# CENTER FOR NUCLEAR WASTE REGULATORY ANALYSES

## NONCONFORMANCE REPORT

Project No. 20-01402-571

NCR No. 2002-10

PLATE # 7

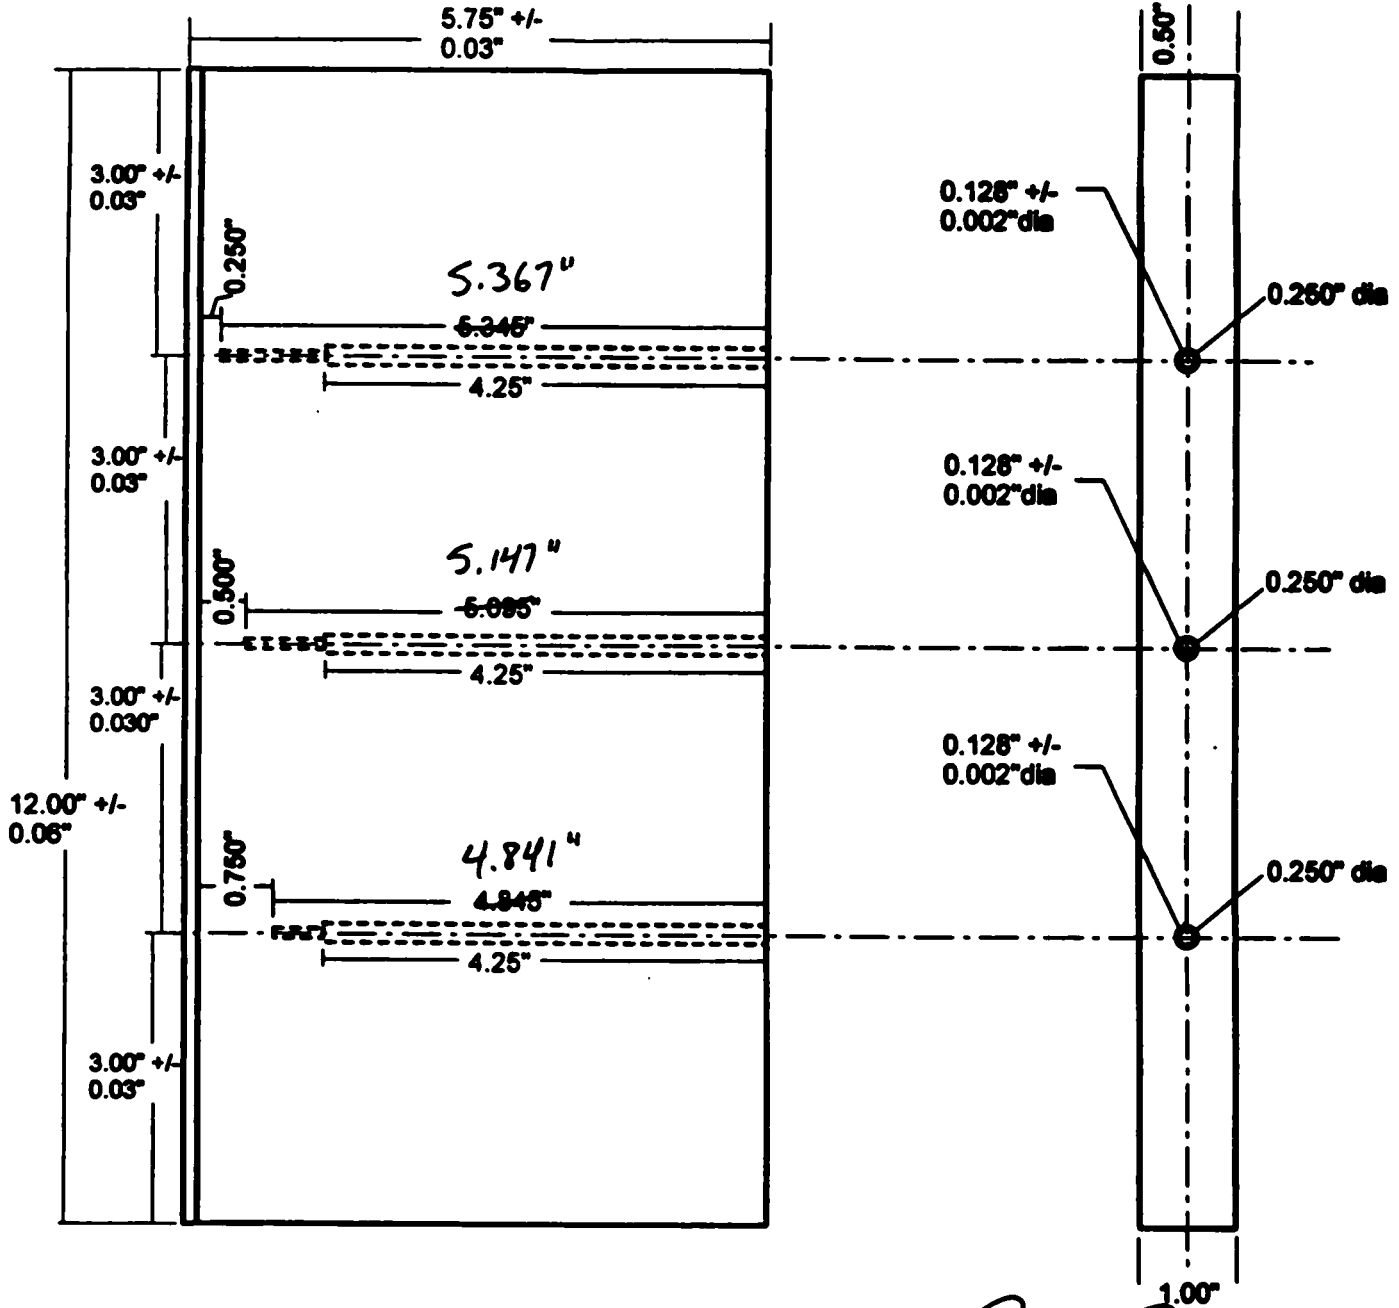
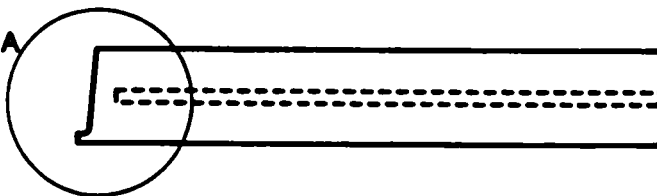
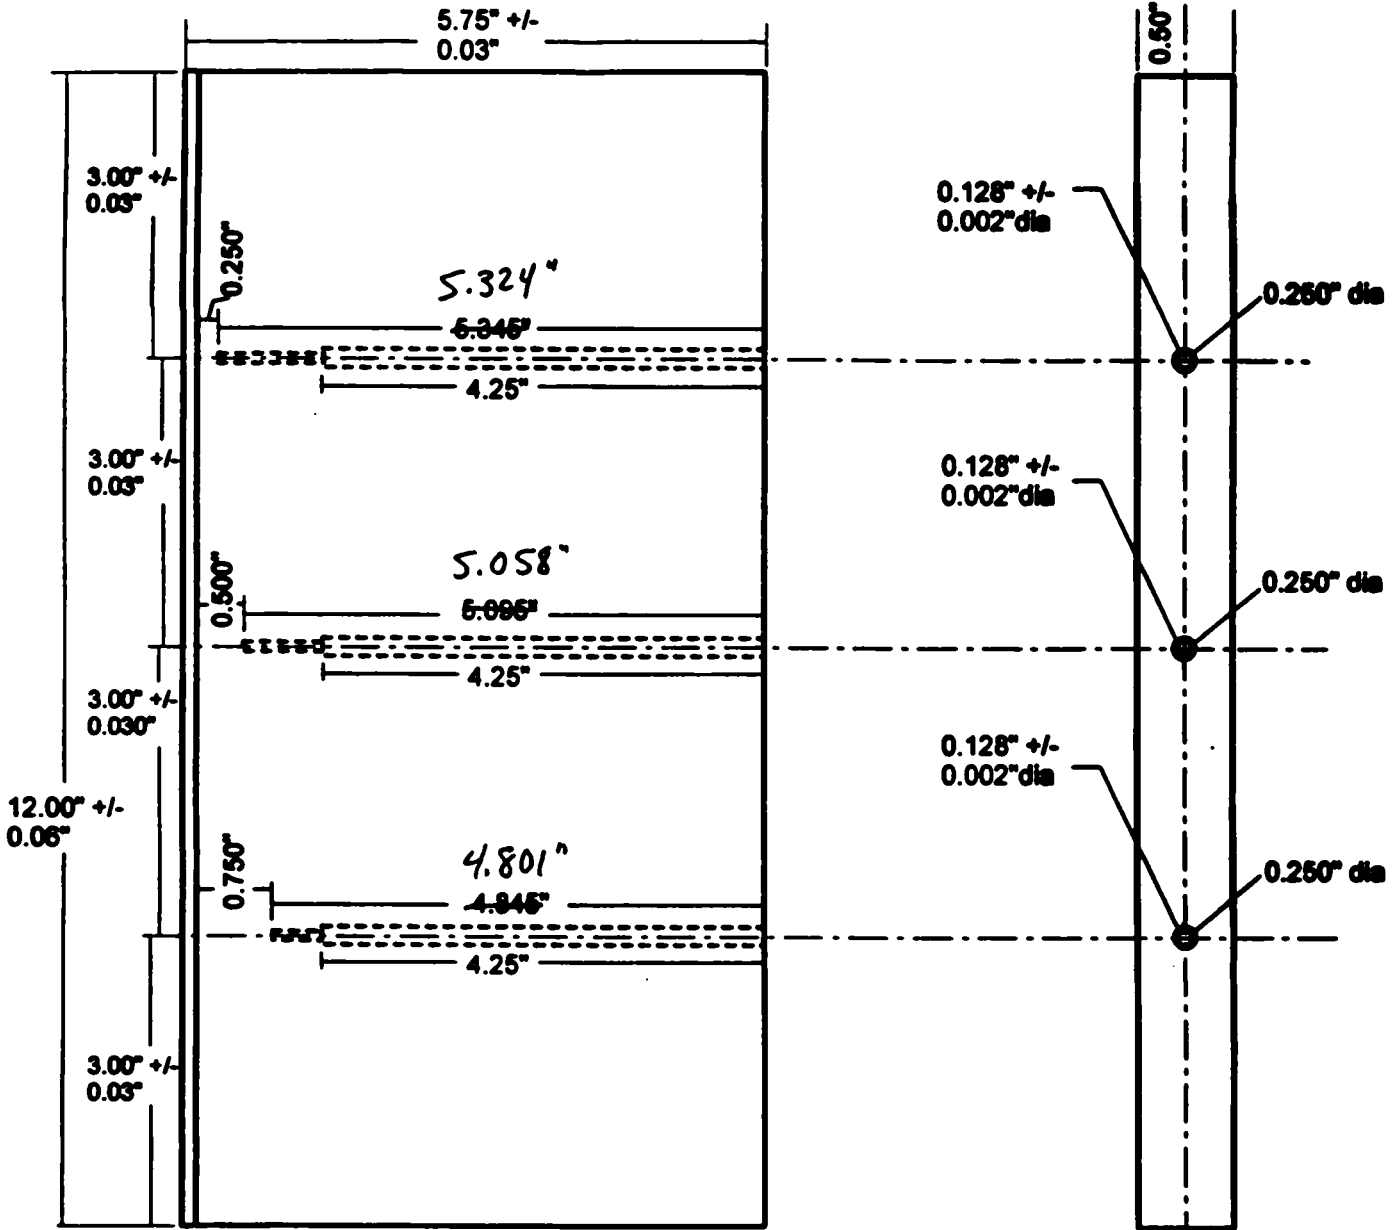
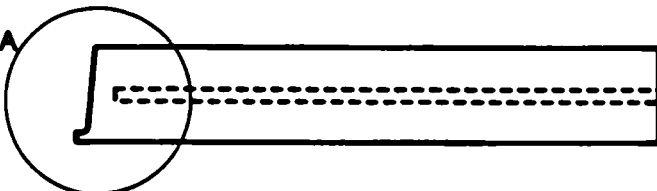
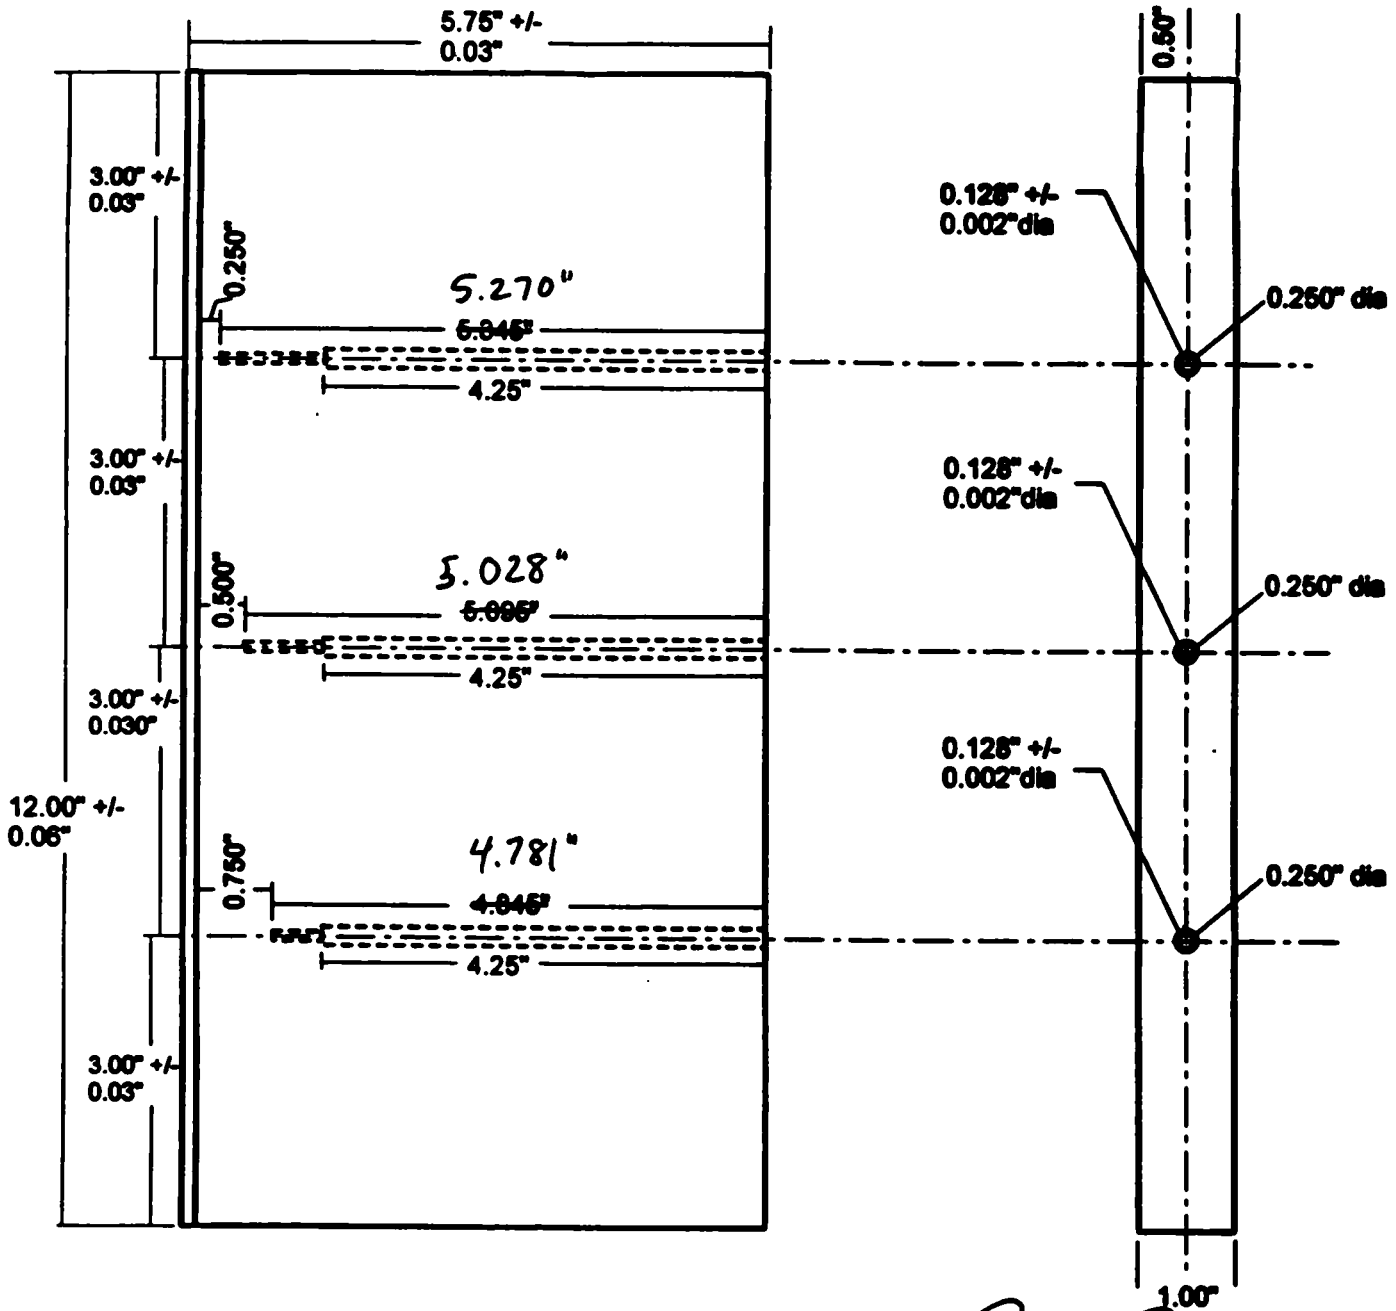
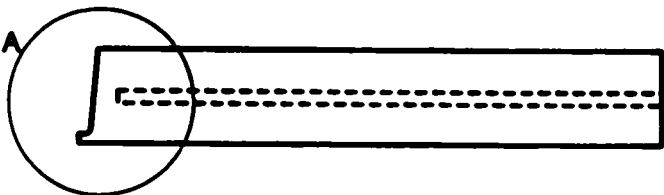
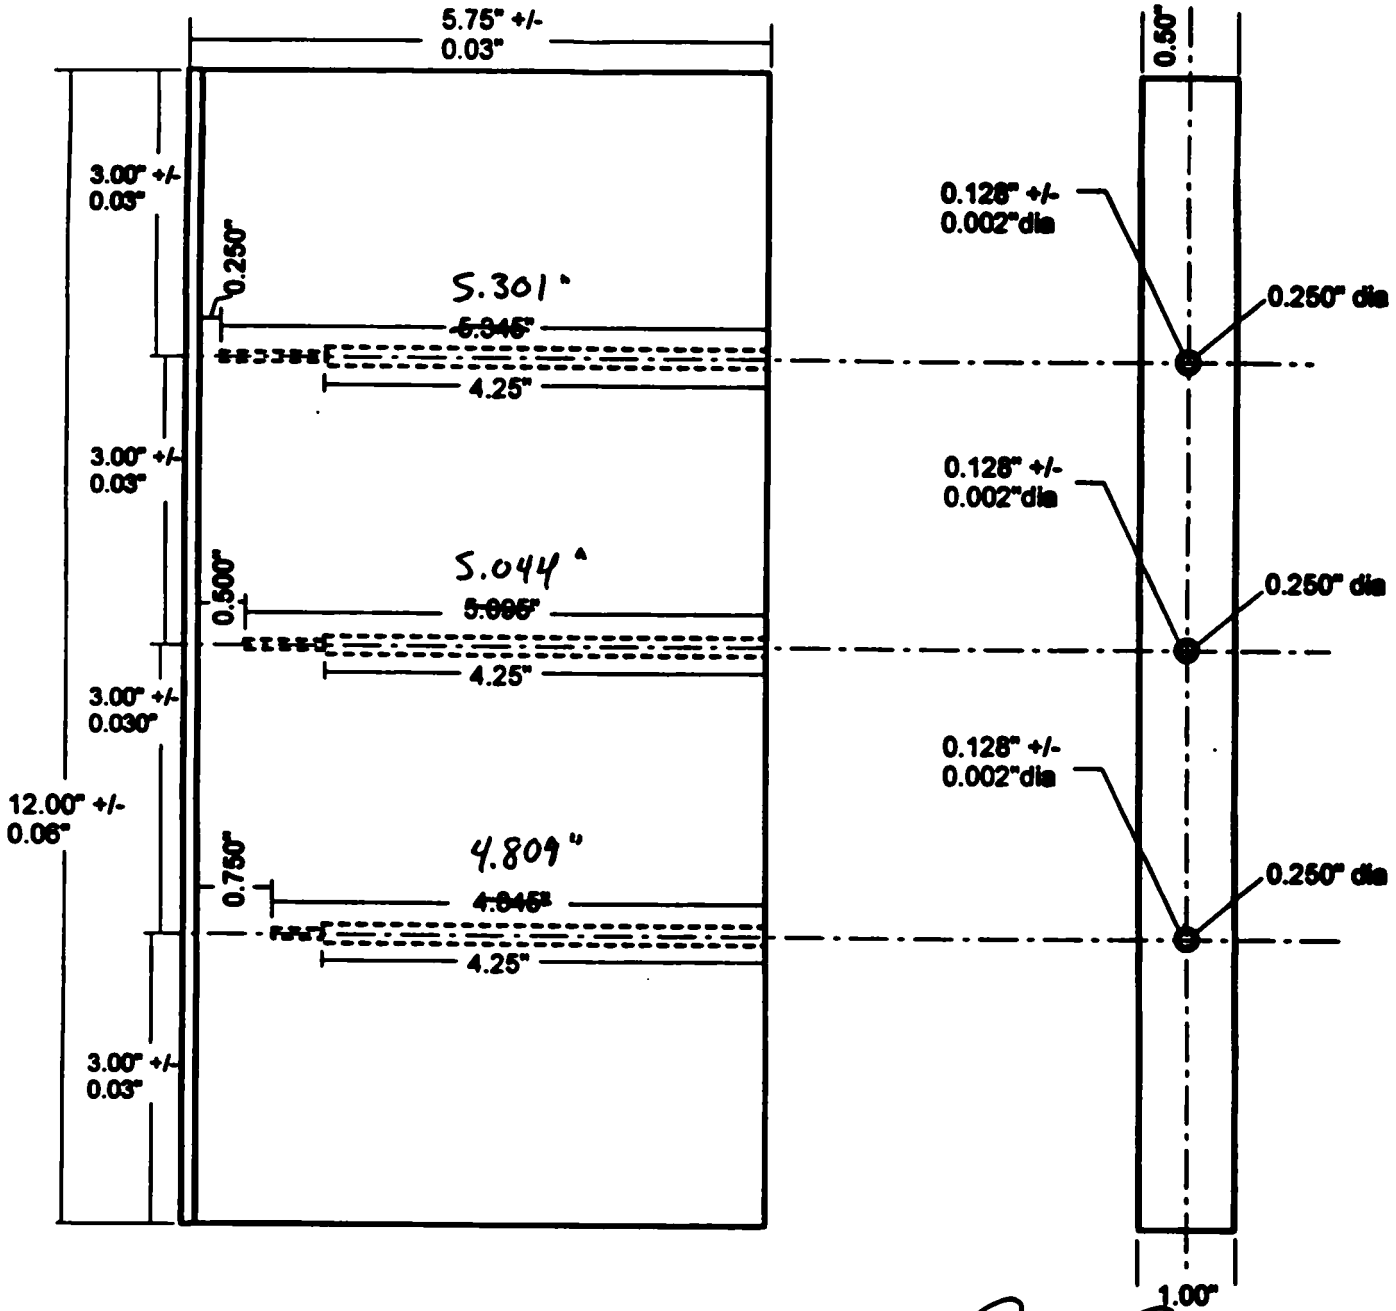
Dimensions of thermocouple holes provided in Drawing 20-01402-571-20 rev 01 are not correct. The depth dimension did not account for the 0.050" dimension of the weld preparation joint. Staff from Texas Toolmakers discovered error during machining of carbon steel mockup plates and informed Darrell Dunn via phone.

As a result of the error in the drawing the location of thermocouples was off by 0.50". This will not affect the welding process and the intent of the mockup plates, which was to approximate the amount of distortion that resulted from the welding process, will not be compromised.

The error in the drawing was discussed with staff at Texas Toolmakers (Mike Ridgway). Texas Toolmakers was instructed to complete machining using dimensions from weld preparation surface and ignore incorrect and redundant dimensions of thermocouple hole depths. Future drawings of weld preparation specimens will not include redundant dimensions. Actual depths of the thermocouple holes were recorded for each machined plate. Measurements made using calibrated micrometer Mitutoyo CD-6" P serial number 06-DC-5 Asset number 002438 calibrated March 25, 2002

Revise drawings to reflect the correct hole depth requirements.  
Record as-built measurements on future drawings. [Signature]
